Predevelopment Plan Review Comments to Applicant

Project Number: PPR2020-00002

Project Address: 50 Alessandro Place

Review of preliminary plans for the Revision of PD-5 by modifying the adopted PD Plan to facilitate construction of a three-story, 60,000 square-foot, medical office building and a five-level, above grade, parking garage with 321 parking space.

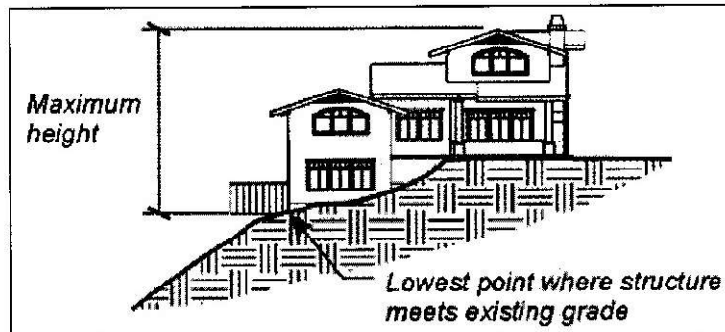
The project proposes a new medical office building with a height of approximately 52 feet, per sheet 6 of the plans, Axon & Section. As proposed the project does not comply and would require an amendment to PD-5. As indicated, there are several two-story residential buildings adjacent and abutting the project site. The proposed building is out of scale and character with the residential properties fronting on Hurlbut Street. It is recommended that the applicant explore alternative options to reduce the massing, revise the design and consider a less intrusive use.

The project proposes a five level parking garage and exceeds the two stories above grade height limit. As proposed the project does not comply and would require an amendment to PD-5 to maintain the proposed heights. The proposed garage structure would be abutting a multi-family zoned neighborhood on its southern boundary. The proposed garage is out of scale and character with the residential properties to the south. It is recommended that the applicant revise the plans to consider a less intrusive use on this portion of the site.

In future plan submittals, label the height of the building measured from the lowest elevation of the **existing grade** at an exterior wall of the structure to the highest point of the structure. The highest point of the structure shall be considered its highest ridge or parapet.

Compliance with the lot coverage maximum of 45 percent cannot be determined at this time. In future plan submittals, include total site area and all portions of the site covered by buildings, roofs, soffits or overhangs extending more than three feet from a wall, and by decks more than four feet in height.

Number Required:

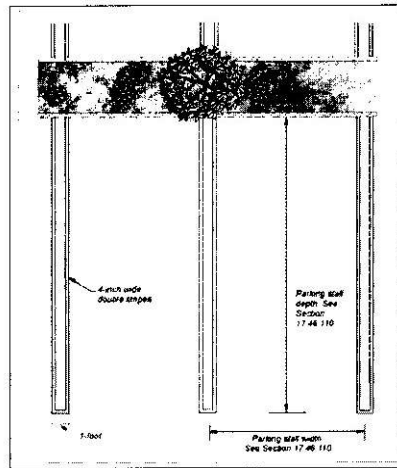
- a) Per Section 17.46.040, the required parking for a *Offices, Medical* land use is four parking spaces for every 1,000 square feet of gross floor area (4:1,000).
- b) The project site is located within a designated Transit-Oriented Development area (Fillmore Station). Per Section 17.50.340.D.1.b(2), nonresidential uses (i.e. *Offices, Medical*) in a transit-oriented area shall reduce the minimum amount of required off-street parking by 10 percent, with an optional reduction up to 20 percent. The 10 percent reduction shall be the maximum allowed number of parking spaces.

The proposed building would provide 60,000 square feet of gross floor area. Based on the discussions above, the range of required parking is 216 spaces (240-10%) and 192 spaces (240-20%). The 10 percent reduction (216 spaces) shall be the maximum allowed number of parking spaces for the new construction.
